IEEE 802.3cg

PLCA strict precedence mode

November 7th, 2018

Figure 148-4—PLCA Control state diagram (continued)

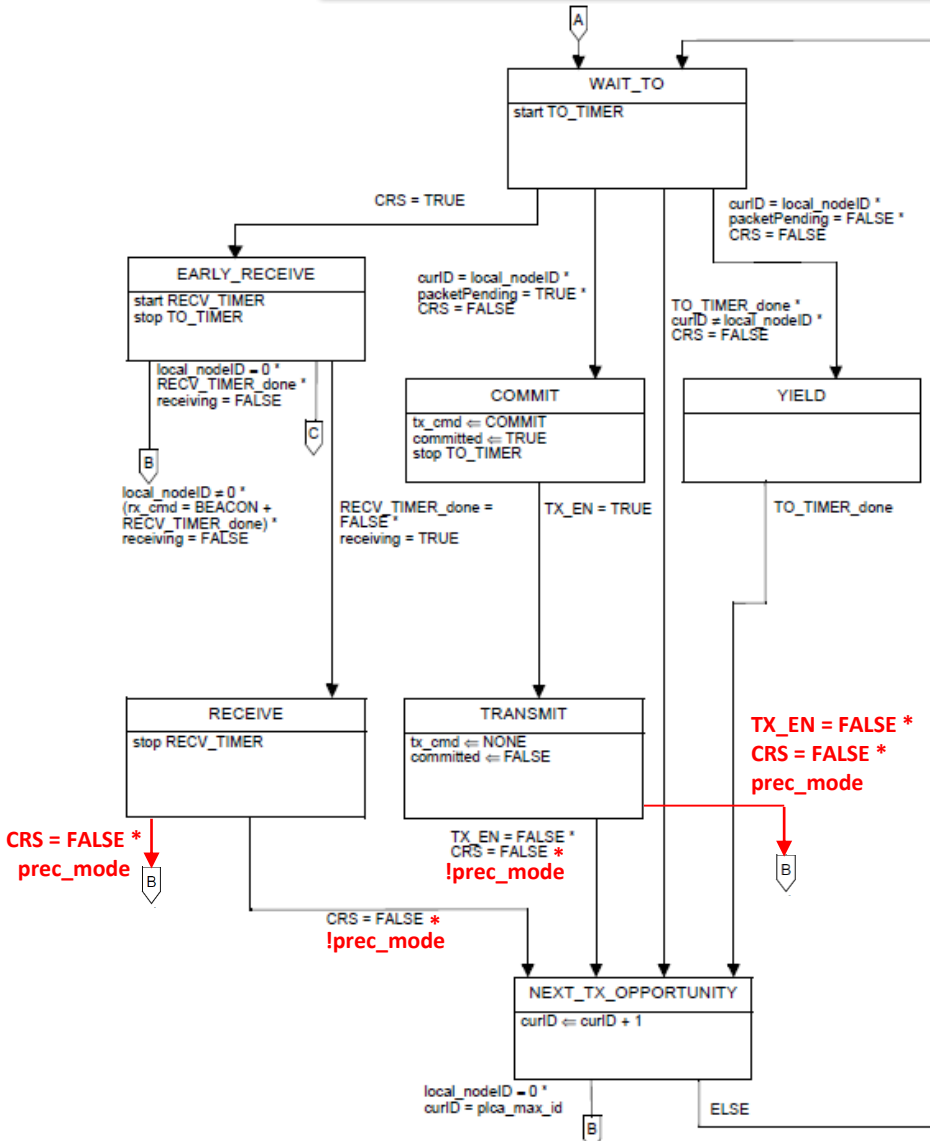
Changes to State Diagrams (C148)
